# Fatman Mods

April 2003

Many of the ideas for these mods were taken from other sources on the web. I wanted to make a complete list of all the changes that I implemented to my Fatman.

Figure 1.  
Pitch, Glide, and Volume

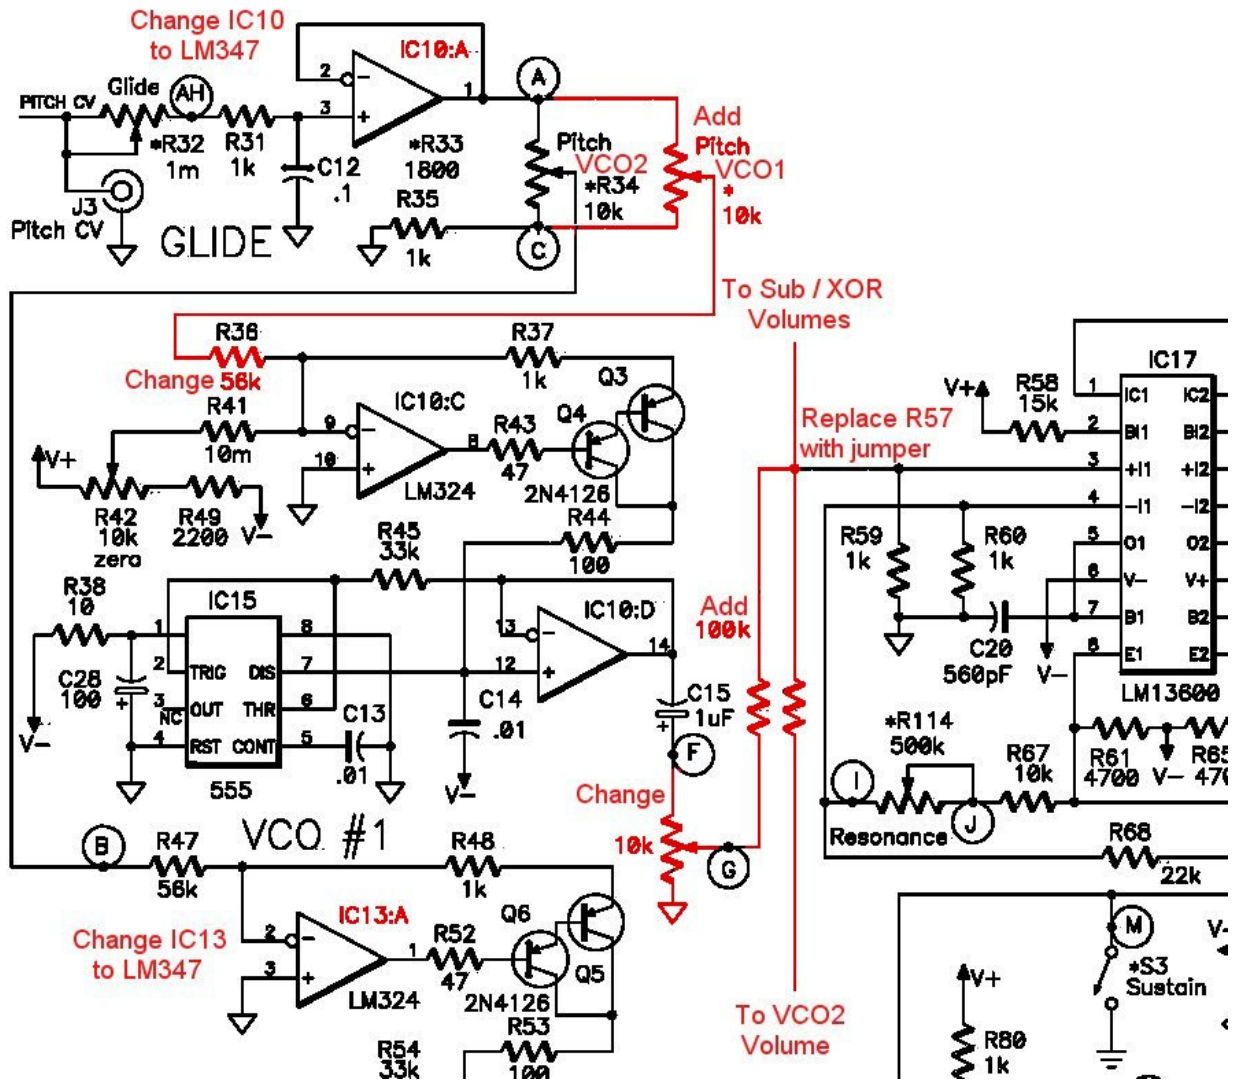
2. Improve ADSR performance: Change R99 from 470K to 320K.
3. Improve VCO Soft Sync: Replace R38 and R39 with LED (figure 2)
4. Lower Frequency Range: Replace R73 with jumper.
5. Improved Glide: Replace IC10 and IC13 with LM347 (lower input bias current prevents detuning when operating the glide control). Re-adjust R42 (figure 1).

6. Independent VCO Pitch Controls: Remove R33. Change R36 to 56K. Change R40 to 10K potentiometer and wire in parallel with R34 (figure 1).
7. Independent VCO Volume Controls: Remove R46 and R55. Replace R57 with jumper. Wire R56 in place of R46. Add 10K volume control and wire in place of R55. Wire the wiper of each potentiometer through 100K resistor to point G (figures 1 & 4).

Figure 2.  
VCO Soft and Hard Sync

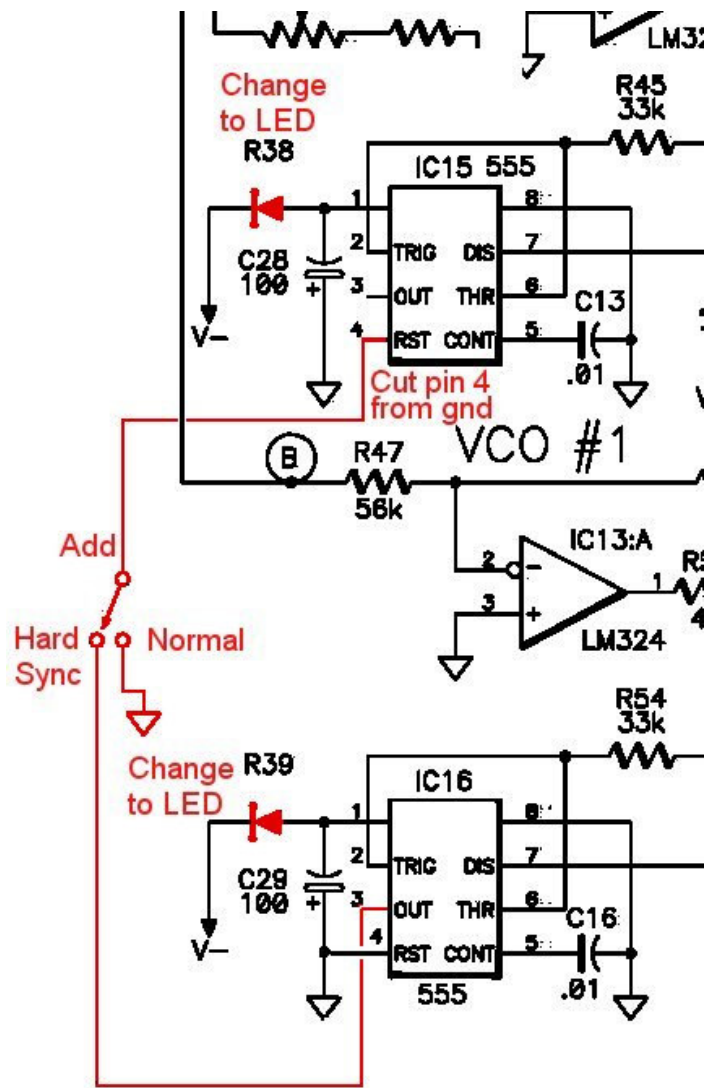
11. VCO1 Hard Sync: Disconnect pin 4 of VCO1 from ground. Wire pin 4 of VCO1 to center of SPDT switch. Wire one side to GND. Wire other side to pin 3 of VCO2 (figure 2).

Figure 3.  
Filter

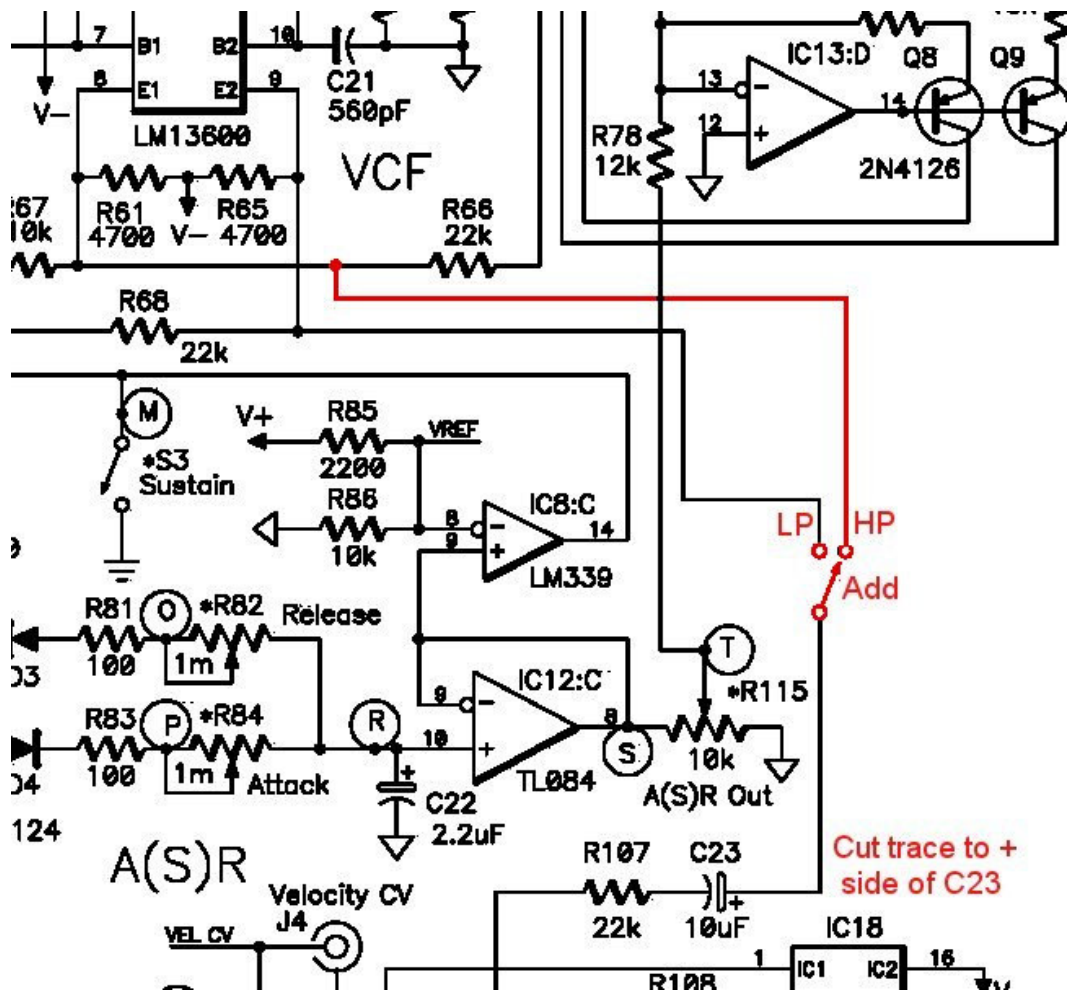
10. HP Filter: Disconnect positive side of C23 from pin 9. Connect positive side of C23 to center of SPDT switch. Wire one side to pin 9. Wire other side to pin 8 (figure 3).
